umweltbundesamt^U
ENVIRONMENT AGENCY AUSTRIA

NPP Paks II

**Paleoseismological assessment of the Siting Report
and the Site License with respect to fault capability**

Geological Site Report, Tóth et al., 2016, Fig. 57

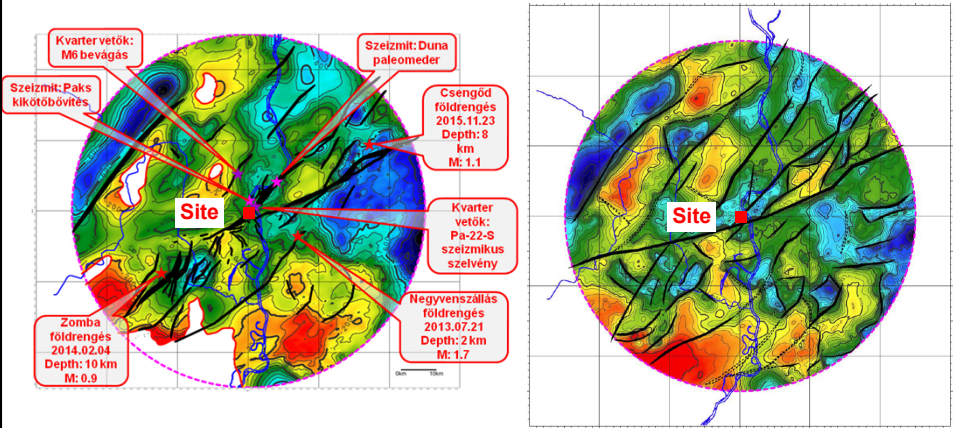
Data proofing active (Quaternary) deformation of the Dunaszentgyörgy-Harta fault zone summarized in the Geological Site Report are not fully reflected in the Site Safety Report.

Geological Site Report, Ács et al., 2016, Fig. 418

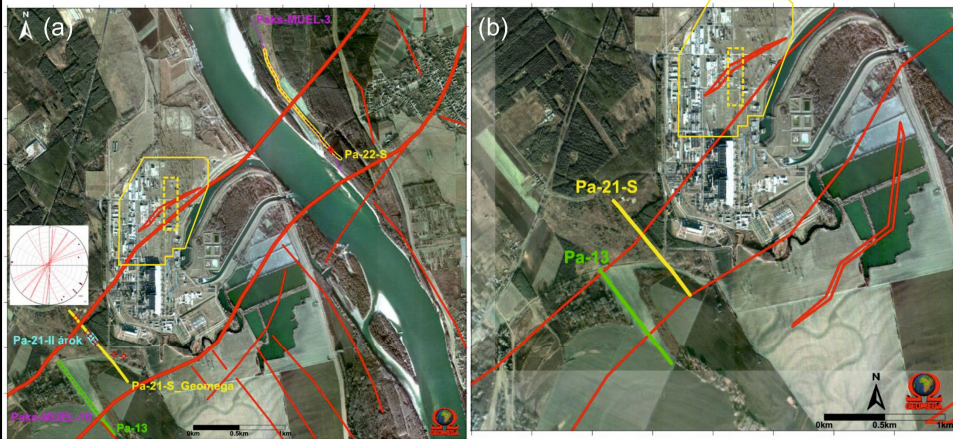
The fault zone indicated by Geological Site Report (left) extends farther North into the perimeter of the new reactor blocks (indicated by broken yellow line).

(A) Location of the paleoseismological outcrops along Highway M-6 (Magyari, 2016). Background map: MVM Paks II Zrt., 2016b, Fig. 5.2.1.2.6-3.

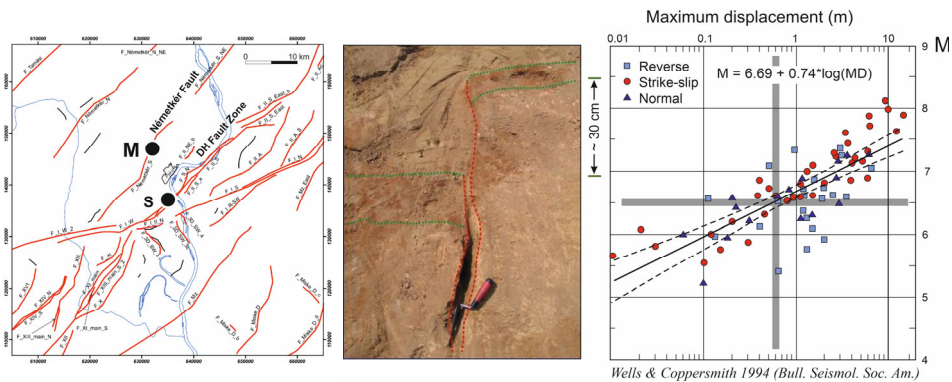
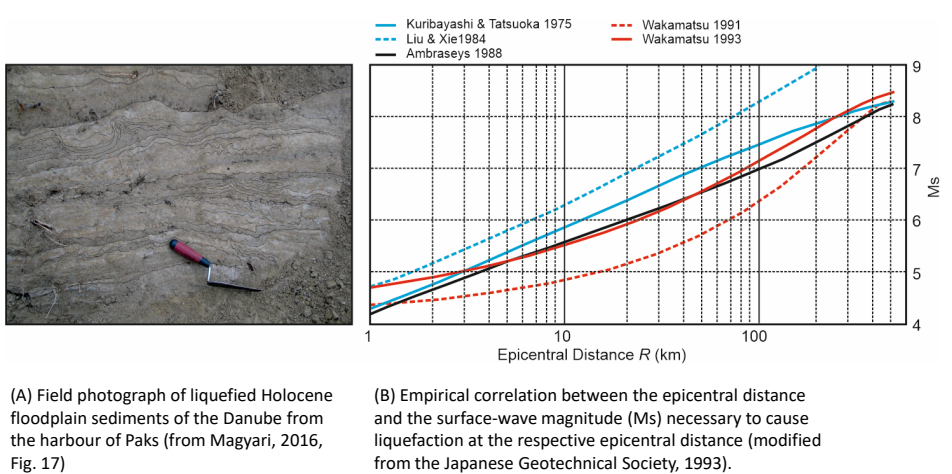
The paleoseismological results obtained from outcrops along Highway M-6 are not reported in MVM Paks II Zrt. (2016a).

(A) Field photograph of liquefied Holocene floodplain sediments of the Danube from the harbour of Paks (from Magyari, 2016, Fig. 17)

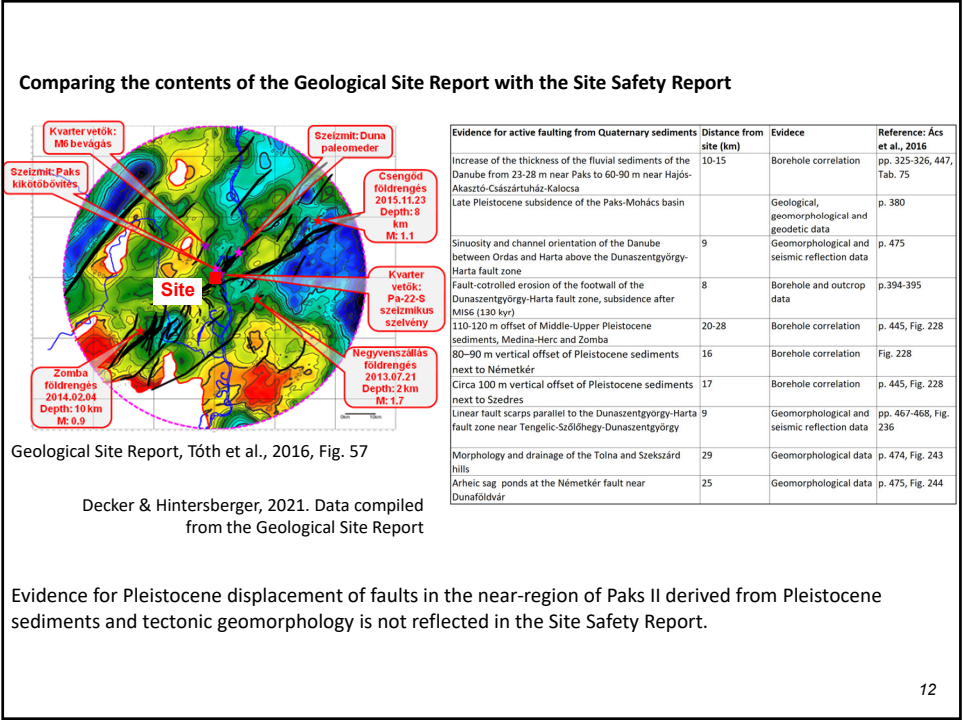
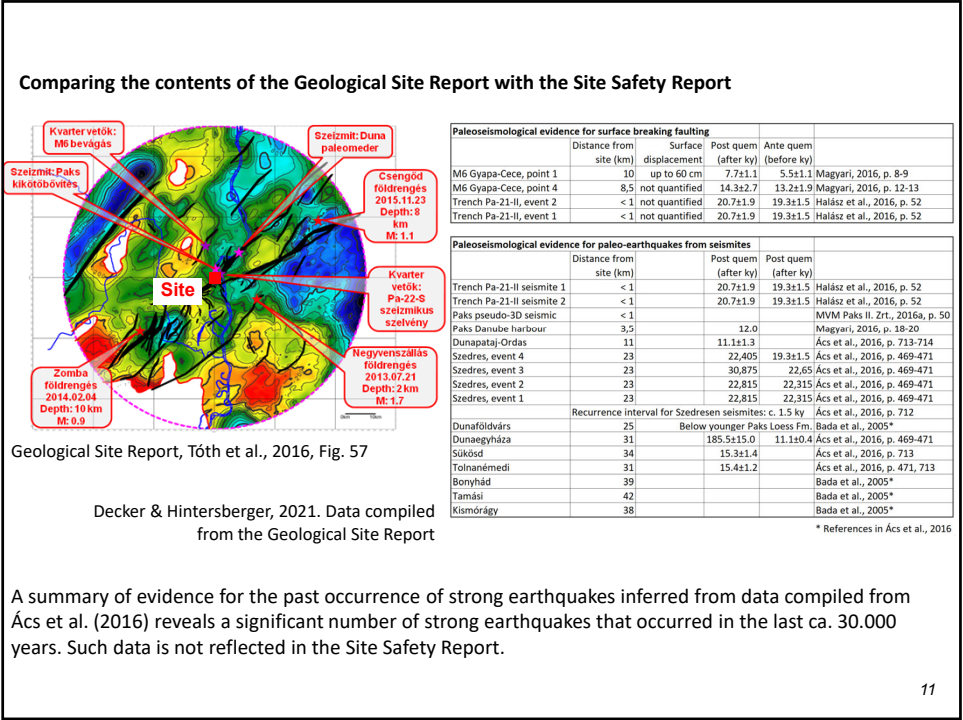
The paleoseismological results obtained from the harbor of Paks are not reported in MVM Paks II Zrt. (2016a).

Geological Site Report, Tóth et al., 2016, Fig. 57

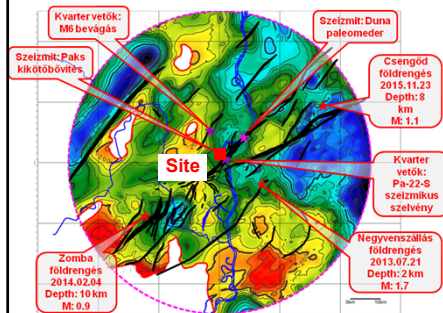
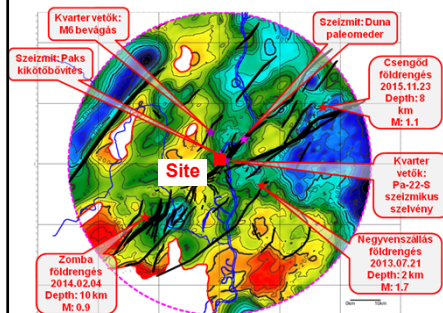
The statement is not supported by data from the Geological Site Report. Data prove vertical offsets of Quaternary strata reaching up to several tens and even 100 m in the near-region of the site. The explicitly stated number of 100,000 years for the age of formations is not substantiated by data.

Figure: Geological Site Report, Ács et al., 2016, Fig. 422

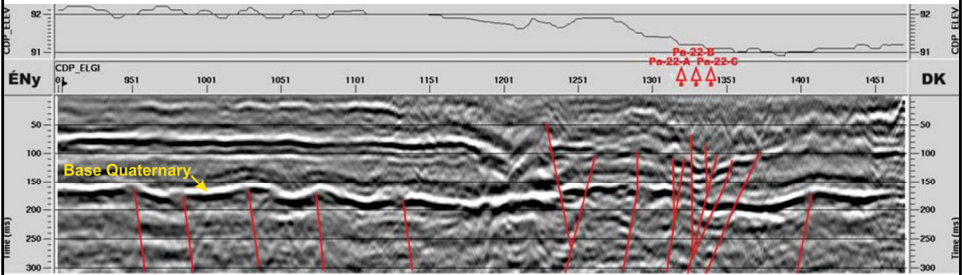
The profile shows 16 individual faults (indicated by the red lines) that offset even the youngest sediments of the Danube. Fault sticks are shown to reach up to about 50 ms TWT (about 5 to 10 m below surface assuming vs 200-400 m/s).

Geological Site Report and Site Safety Report do not contain paleoseismological data from the faults imaged by seismic (and resistivity) profiles.

Figure: Geological Site Report, Hálasz et al., 2016, Fig. 9

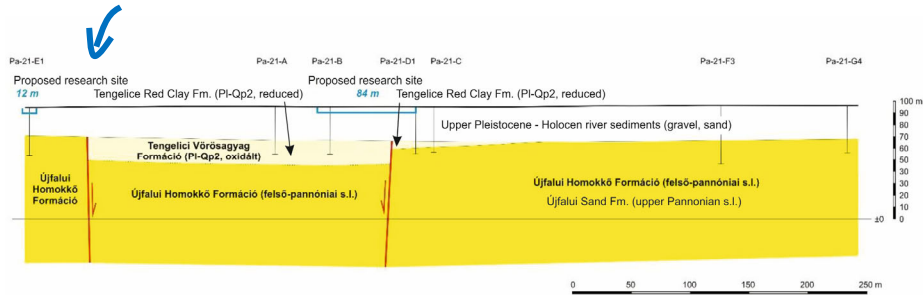
Geological profile derived from 7 shallow boreholes (Pa-21-A-G) and seismic section Pa-21-S-Geomega showing the vertical offset of the Tengelic Red Clay Fm. (Early Pleistocene, 1–2 Ma). The vertical offset of the base of the formation is about 20 m in the strike-slip environment of the Dunaszentgyörgy-Harta fault zone.

Geological Site Report and Site Safety Report do not contain paleoseismological data from the fault(s) truncating the Tengelic Red Clay Fm. to the NW.

Seismic profile Pa-21-S across part of the DHFZ (700 m SE of the existing NPP Paks)

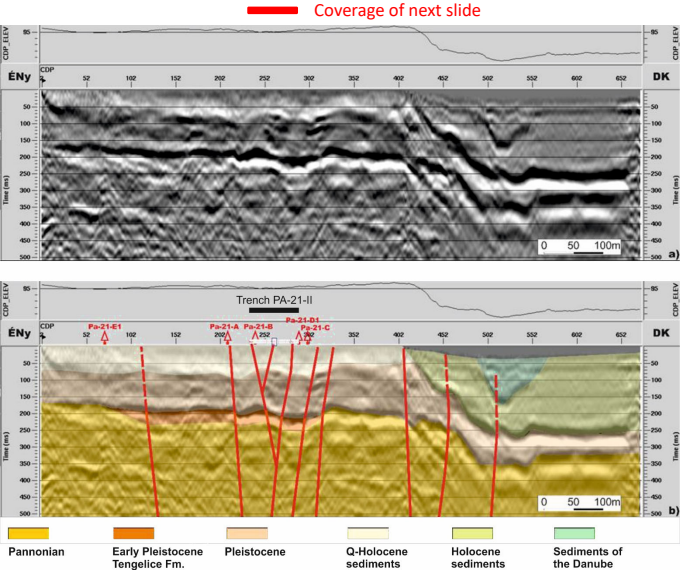
The profile shows 10 individual faults (indicated by the red lines) that offset even the youngest sediments of the Danube. These faults are shown to reach up to the surface.

Figure: Geological Site Report, Hálás et al., 2016, Fig. 11 and 12

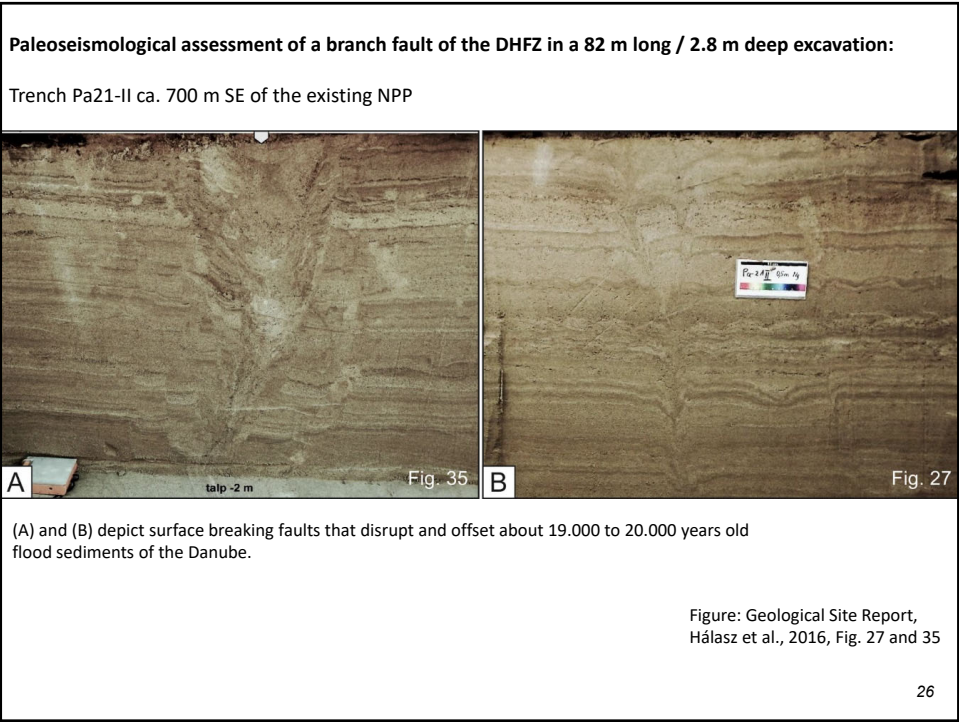
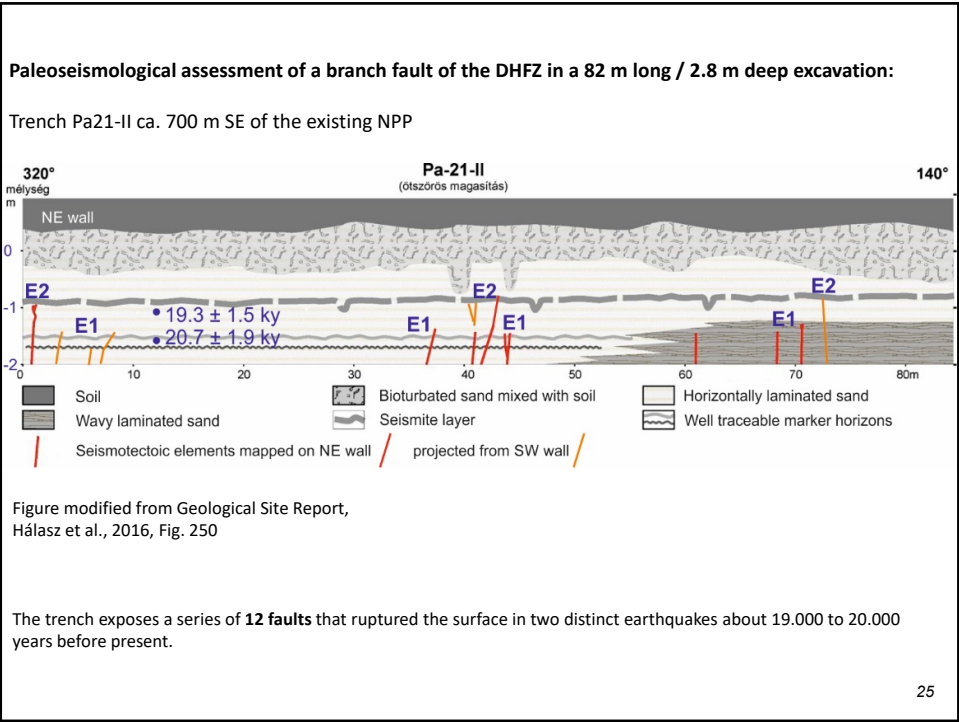
(A) depicts a surface breaking fault that disrupts and offsets about 19.000 to 20.000 years old flood sediments of the Danube.

Figure: Geological Site Report,
Hálasz et al., 2016, Fig. 32

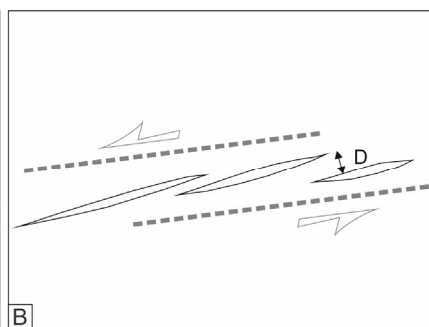
(A) Sediment filled en-échelon tension gashes erroneously interpreted to record sinistral slip and 2.5 cm horizontal displacement (from Hálasz et al., 2016, Fig. 32; Frank Horvath for scale).

(B) schematic sketch of a sinistral shear zone with en-échelon tension gashes showing that the measurement in (A) measures the horizontal spacing of the sediment-filled tension gashes. The amount of sinistral displacement remains undetermined and may exceed the stated value significantly.

Background photo: Halász et al., 2016, Fig. 35

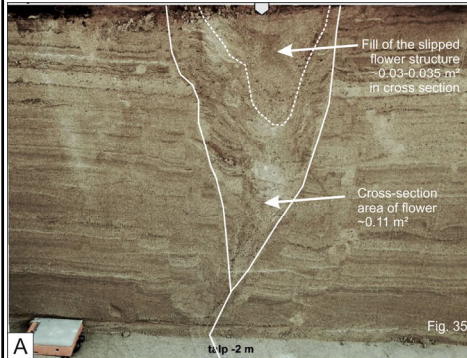
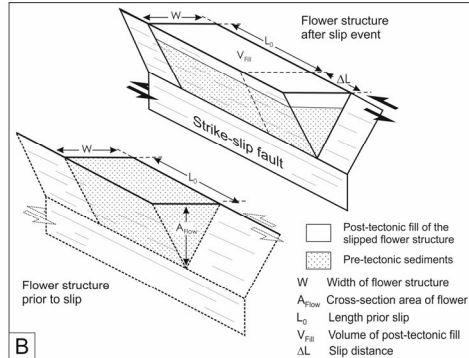
(A) Negative flower structure at 43.7 m of the trench Pa-21-II, interpretation by Decker & Hintersberger, 2021. The continuous white line indicates the boundary faults of the flower structure; the broken line delimits sediments of the post-tectonic fill.

(B) Schematic shoebox model illustrating the geometry of a negative flower structure. A slip distance of 0.3-0.4 m is calculated from the dimension of the trenched structure (cross-section area 0.03 to 0.035 m²; minimum length 1.3 m; minimum volume of sediment fill 0.039 to 0.046 m³).
